## **LOTS ROAD NEIGHBOURHOOD FORUM RESPONSE TO MOUNT ANVIL'S LOTS ROAD SOUTH PLANNING APPLICATION**

### **Introduction**

Fig. 2 The negative impact of Mount Anvil's proposed building heights looking North

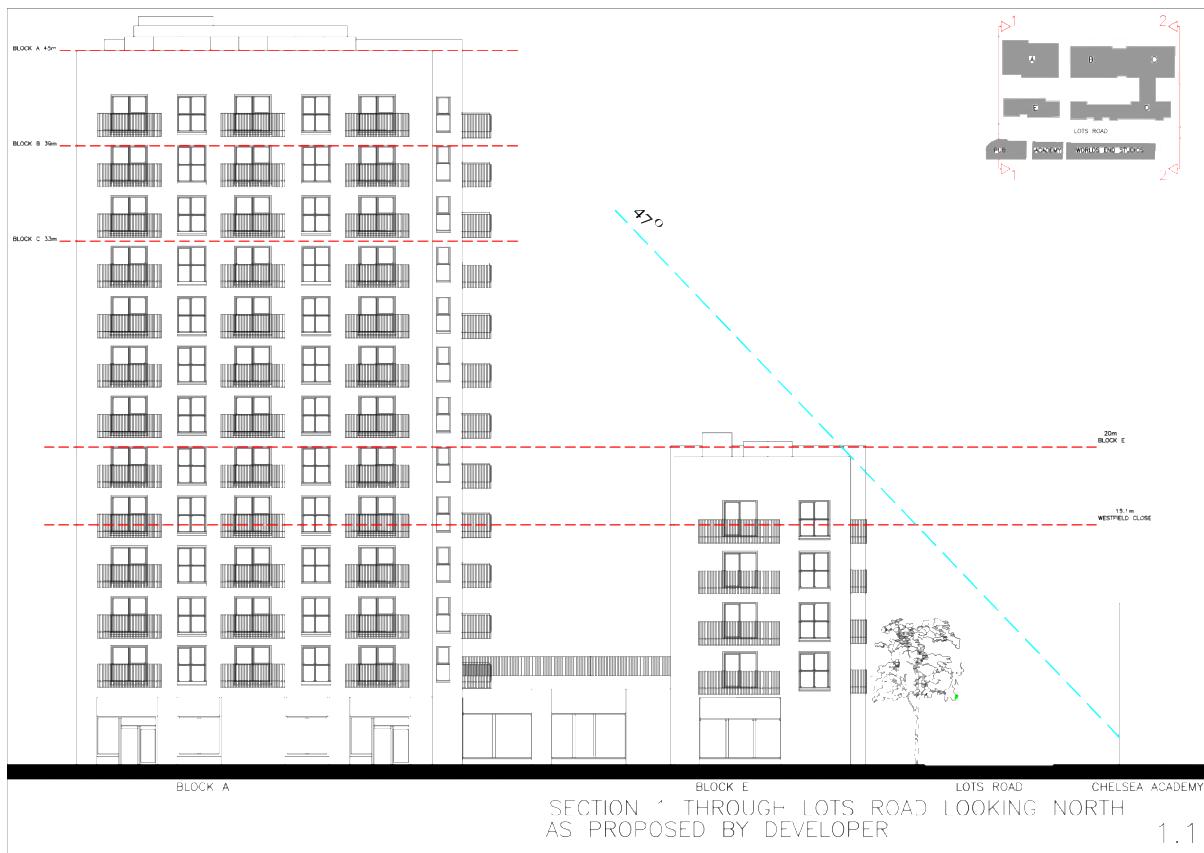
With this image you may be tempted to think that Blocks D and E, are of a similar scale to the buildings on the opposite side of the road or the taller five-storey buildings that can be viewed further towards the King's Road (Westfield Close and 554 King's Road). To dispel this false impression, the Forum has therefore prepared a more accurate drawing to illustrate the adverse effect of the proposed building heights, which are substantially larger than both those opposite and the existing five-storey building on Lots Road (Fig. 2).

Fig. 4 The negative impact of Mount Anvil's proposed Block D looking South

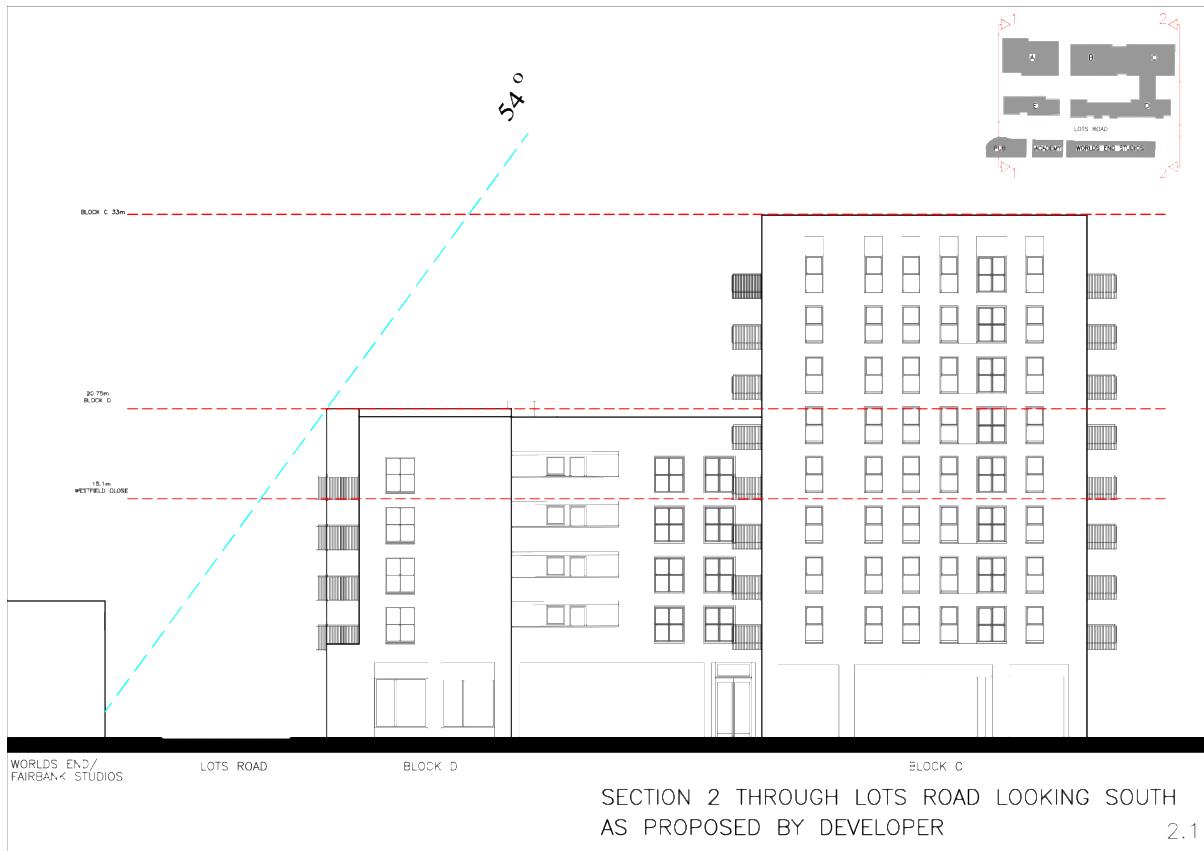
The site is immediately adjacent to and opposite the Lots Road Conservation Area. The proposals will result in a visual restriction, particularly between Block D and the 2-3 storey buildings opposite, which are in the Conservation Area (Fig. 4).

The stated height of Blocks D & E is five storeys; however, with a 5.5m ground floor storey height and a rooftop parapet in excess of 1m high, they will appear and should be considered as six storeys. While Mount Anvil have argued that the parapet height is a safety measure on the rooftop, this could be achieved with a safety barrier placed further back on the roof away from the building edge, thus avoiding the need for the parapet height.

At the northerly end of the site facing Lots Road, the prominent face of Block D is shown either on or very close to the existing pavement edge (see Fig. 4). Here, the pavement width is shown as 2.4m (this being only 0.25m more than the existing). The Green route, located on the west side of the site, adjacent to the railway line, has been abandoned, and access to the creek is limited due to the site's size. The proposed Lots Road façade is mostly continuous, and the larger part of the communal gardens is at first-floor level and private. The local community is determined that the streetscape amenity should be part of the local benefit.

**Proposal 1.1** - The heights of Blocks E & D are effectively six storeys high. These heights should be reduced to five storeys in line with other buildings along Lots Road. The reduction in height can be achieved by some or all of the following measures:

Fig. 5 Illustration of LRNF's proposed reduction in the heights of Blocks D and E

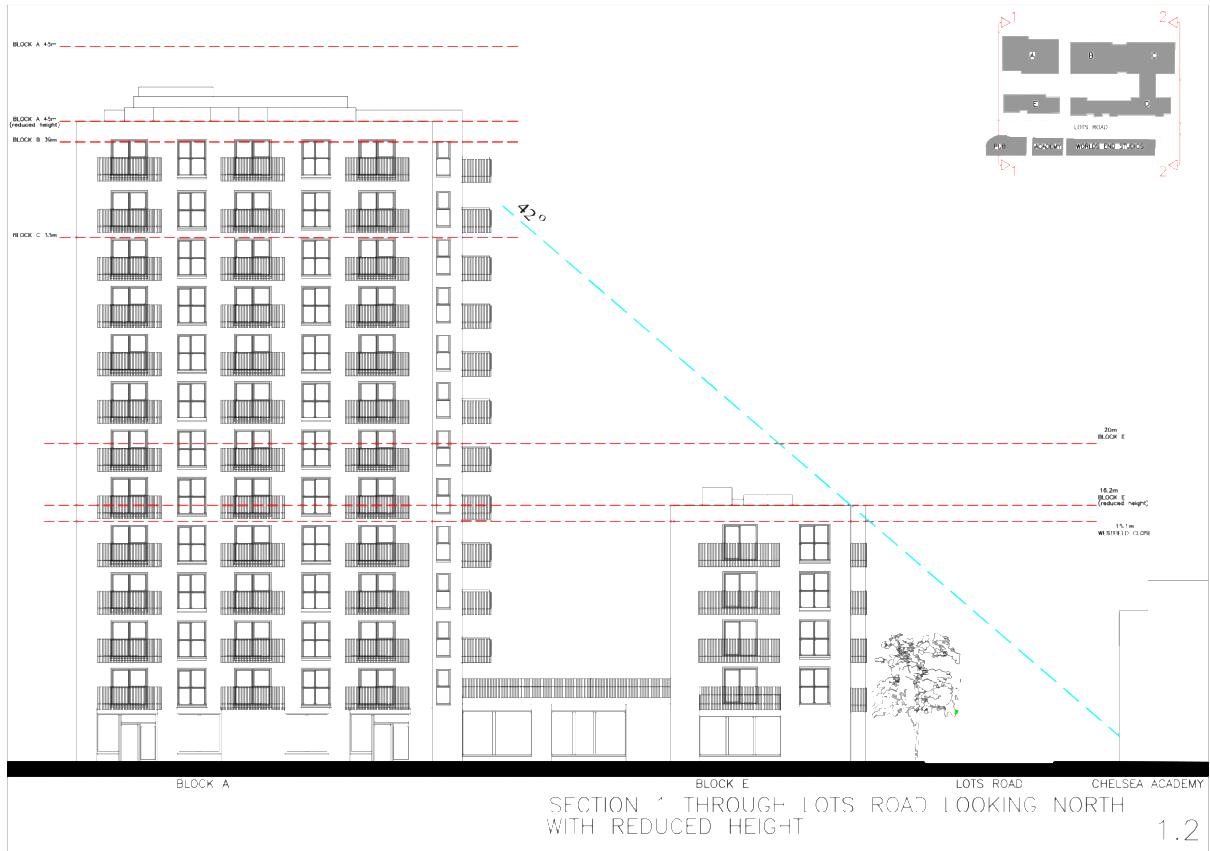
The benefit of this reduction can be clearly in the drawing at Fig. 5. The height would be closer to the Westfield Close block in Lots Road, and the canyonisation of Lots Road, along with the negative effects this will have on the Conservation Area, will be partially ameliorated. This proposal should have both cost and environmental benefits, reducing the amount of construction materials needed.

- Reducing significantly the parapet heights. At the perimeter, the roof thickness may be increased away from the parapet to allow the introduction of additional insulation, green roofs, photovoltaic panels, etc.
- Safe roof access achieved with a fall arrest system and/or recessed guard railing/panels.
- Reducing the residential floor storey heights
- Reducing significantly the ground storey height

The new height should be approximately that of Westfield Close, resulting in a reduction of up to 5.8m across Blocks D and E.
